Service Information Bulletin

SUBJECT	DATE
DD15 and DD16 Axial Power Turbine	May 2014

Additions, Revisions, or Updates

d090062

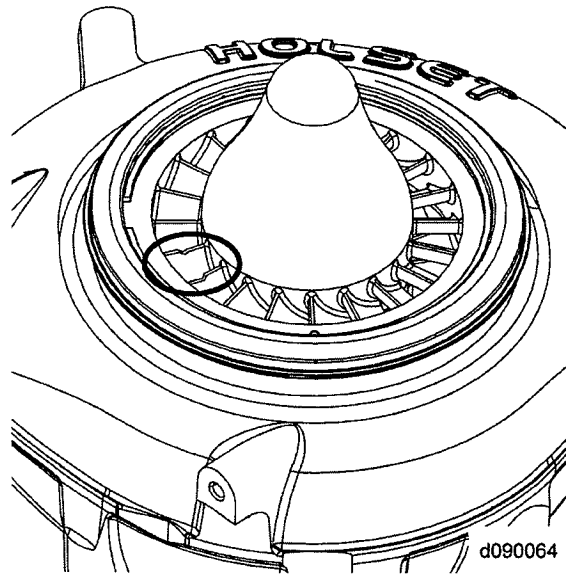
Publication Number / Title	Platform	Section Title	Change
DDC-SVC-MAN-0081	DD Platform	Inspection of the DD15 and DD16 Axial Power Turbine	Added instruction to inspect for the correct location of oil seal O-ring.
DDC-SVC-MAN-S181	Euro IV	Inspection of the DD15 and DD16 Axial Power Turbine

1. Remove the Axial Power Turbine (APT) from the gearbox and ensure the O-ring is installed in the narrow groove (1) on the snout of the APT.
